Parks, Recreation & Culture

Invatation to Tender No. 2025-PRC-02
Forrest Field – Phase 2

This Addendum contains:
Addendum #3 - Q&A.

Question 9. Image

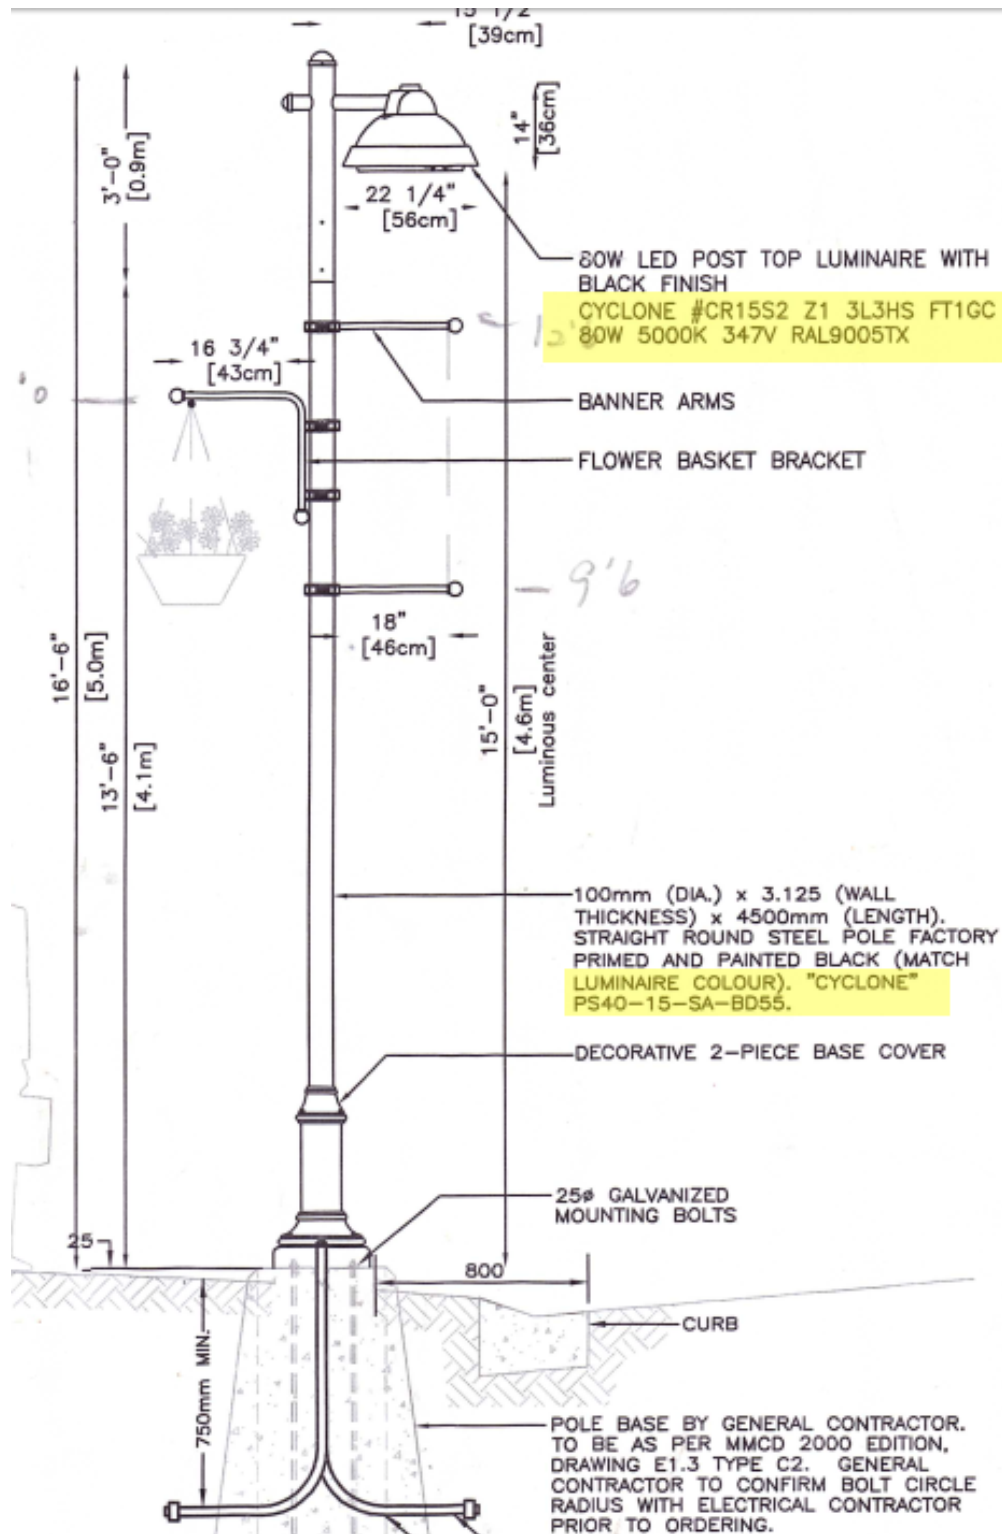
9. Is there a preferred street light model, approved by the Town of Ladysmith, to be used on this project?

A9: There is no preferred model. Street light model is to meet specifications shown on the electrical drawing. The new lights should have a consistent look to the existing lights in the lower parking lot at Forrest Field (see attached photo)
